Status & Remarks

35 U.S.C. §112

FIG-3

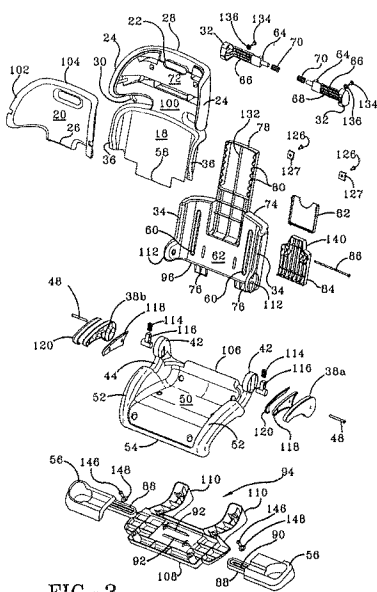
Specifically, the Office has indicated that claim 1 recites "an upwardly-extending projection having at

least two releasable means for securing said movable component in either said retracted or said at least one extended position.” The Office has assumed that this recited upwardly-extending projection corresponds to the disclosed projection 64.

The applicant’s attorney regrets the confusion which apparently was caused to the Office, and has amended the claim to remove this confusion. The applicant’s attorney intended that the “upwardly-extending projection” correspond to the component labeled 78 in Fig. 3.

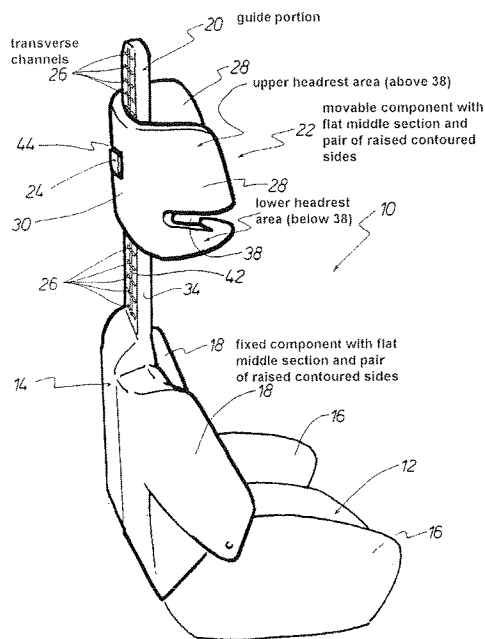
It is not understood how the examiner can conclude that there is "*a surface and contour of the lower area in cross-section for sliding movement along a mating contoured surface in cross-section of the fixed component*" in that there is no sliding whatsoever between the two components.

Additionally, there does not appear to be any teaching which shows "*movement from the retracted position to the extending position occurring by sliding movement of the moveable component over the fixed component along the raised contoured sides of both the fixed and movable components*" in that there is no sliding over any contours.

One of the keys to the applicant's invention is the fact that there is no "gap" between the fixed and movable components. When the *Reithmeier* car seat is in its extended position as illustrated to the left, there is without question, a gap between the fixed and movable component, a feature which is highly undesirable whether the gap is in the pelvis area (as illustrated by *Lovie* discussed below, or in the shoulder area (as illustrated by *Reithmeier*). There is no corresponding teaching to "*the fixed and movable components in an overlapping essentially gapless relationship*" as there most assuredly is a gap in *Reithmeier*.

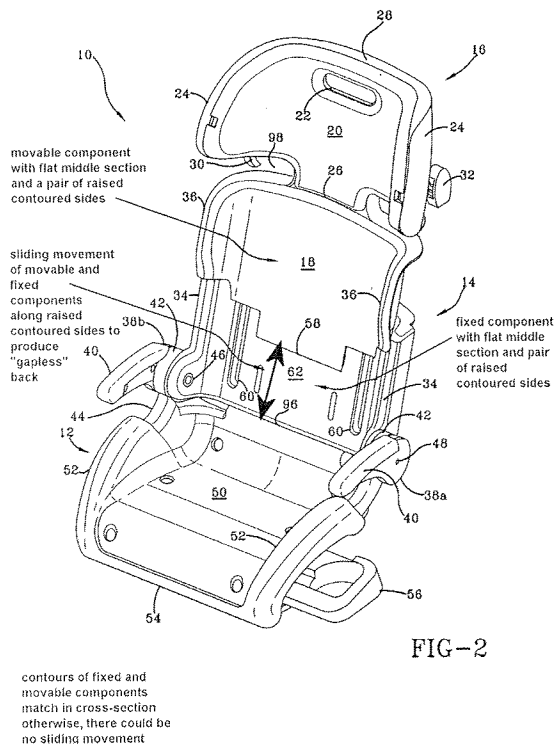
art identified by the examiner, or which the applicant and/or his attorney is aware of. For purposes of illustration, the applicant's attorney has focused on these distinctions in the annotated graphic below.

In the applicant's invention, it is correct to state that there is "a surface and contour of the lower area in cross-section for sliding movement along a mating contoured surface in cross-section of the fixed component."

In the applicant's invention, it is correct to state that there is "movement from the retracted position to the extending position occurring by sliding movement of the moveable component over the fixed component along the raised contoured sides of both the fixed and movable components."

In the applicant's invention, it is correct to state that there is no "gap" between the fixed and movable components and therefore, "the fixed and movable components [are] in an overlapping essentially gapless relationship".

FIG-2

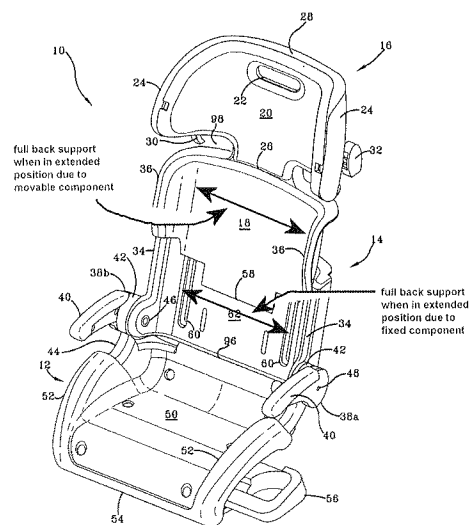
The Office has represented that Lovie may teach the missing components. However, this is a most selective reading of *Lovie* and represents parsing the claims and teachings into meaningless isolated statements. The Office has apparently ignored two meaningful limitations which are present in combination in claim 41, namely:

- A movable component which has a lower area below the seat belt indentations, the lower area having a contour in cross-section for sliding movement along the fixed component which has a mating contour in cross-section; and
- A lower area fixedly connected to the upper headrest area of the movable component.

No reference which the examiner has identified has this combination, the value of which is that the occupant has complete back support both in the pelvis area (thereby overcoming a shortcoming of *Lovie*) and in the neck region (thereby overcoming a shortcoming of *Reithmeier*) as illustrated below. This is an unobvious improvement over the prior art, and certainly not within the teachings of either *Reithmeier* and/or *Lovie* taken individually or in combination.

Meeker & Gibson invention

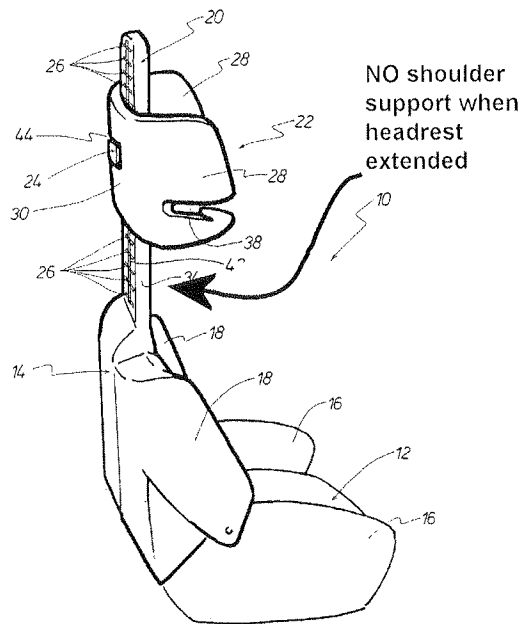
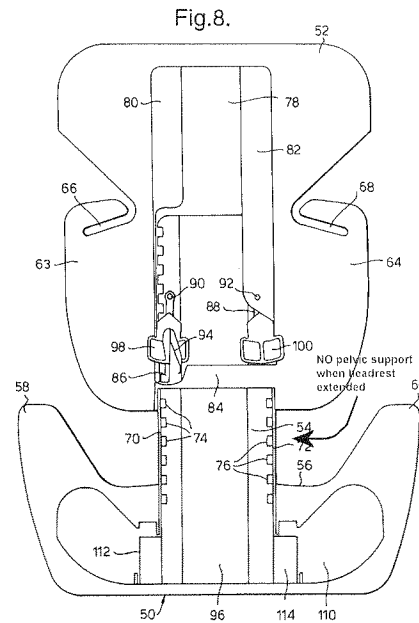
Traditional logic would have employed a center rail arrangement as taught by *Reithmeier* and *Lovie*, thereby leaving the occupant exposed in either the pelvis area or in the shoulder area, both of which are undesirable configurations in a rear-end collision. The *Meeker & Gibson* invention overcomes the limitations of the prior art in a manner which is reflected in the claims.
